Work Order ID 154608

Item ID: D206-781-041 Accept *N900040100* Setup Start *NS1*
 Revision ID: Stop *NS2*
 Item Name: Baggage Compartment Protector - Wall
 Start Date: 12/16/2016 Start Qty: 5.00 *5* Cust Item ID:
 Required Date: 12/21/2016 Req'd Qty: 5.00 *5* Customer:
 Reference:

DART SERVICE INSTRUCTION

TO AMEND INSTALLATION INSTRUCTIONS IIN-D407-781-2 REV. A OR LATER APPROVED REVISION
AND INSTRUCTIONS FOR CONTINUED AIRWORTHINESS ICA-D407-781 REV. 3 OR LATER REVISION

**FIGURE 1 - D3879-1 BAGGAGE COMPARTMENT WALL
PROTECTOR - ALTERNATE INSTALLATION**

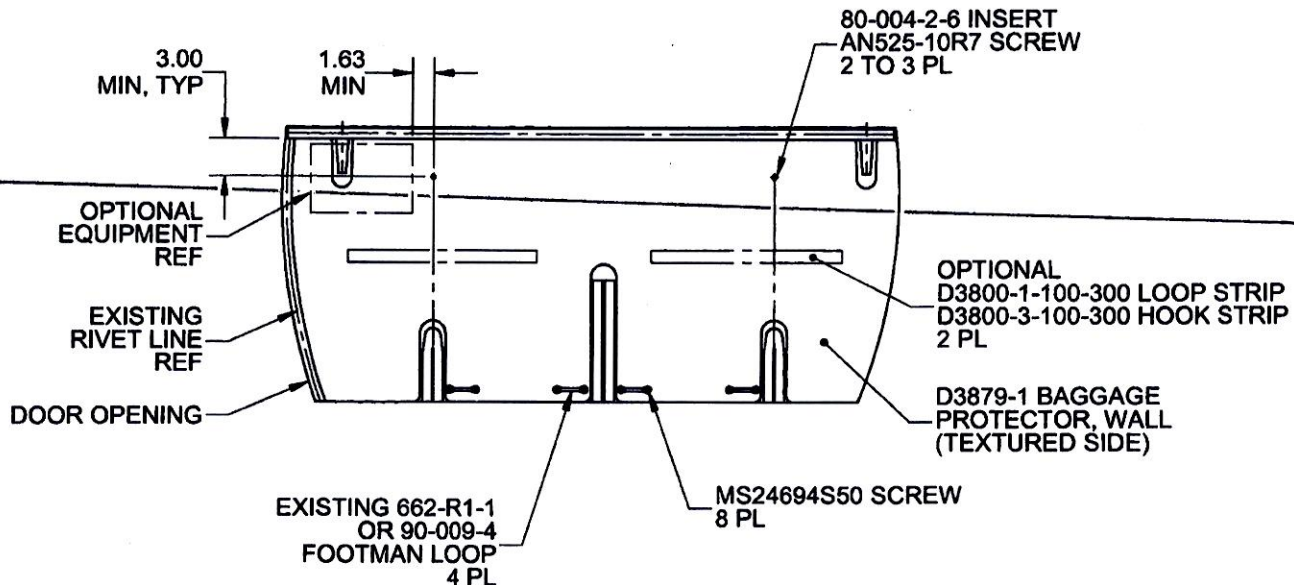
In some aircraft, the top portion of the D206-781-041 Baggage Compartment Wall Protector Kit cannot be installed as indicated in IIN-D407-781-2. The purpose of this DSI is to provide an alternate mounting method to fasten the top portion of the D206-781-041 Baggage Compartment Wall Protector Kit.

It is acceptable to replace qty(2) D3930-1 Clips with qty(2) 80-004-2-6 Inserts. Locate and mark location of the two attachment holes on the baggage compartment wall as shown in Figure 1 of this service instruction. Install 80-004-2-6 Inserts at the marked locations in accordance with Section 3-2-12 of BHT-206-SRM-1. It is acceptable to trim the wall protectors to accommodate optional equipment or transfer attachment holes to the wall protector and install the optional equipment on top of the wall protector with longer fasteners.

Amend the D206-781-041 Baggage Compartment Wall Protector Kit parts list as follows:

Qty -061	Qty -031	Qty -041	Part Number	Description
X			D206-781-061	BAGGAGE COMPARTMENT PROTECTOR KIT (FLOOR AND WALL)
1	X		D206-781-031	BAGGAGE COMPARTMENT FLOOR PROTECTOR KIT
1		X	D206-781-041	BAGGAGE COMPARTMENT WALL PROTECTOR KIT
		2	AN525-10R7	SCREW
		2	80-004-2-6	INSERT
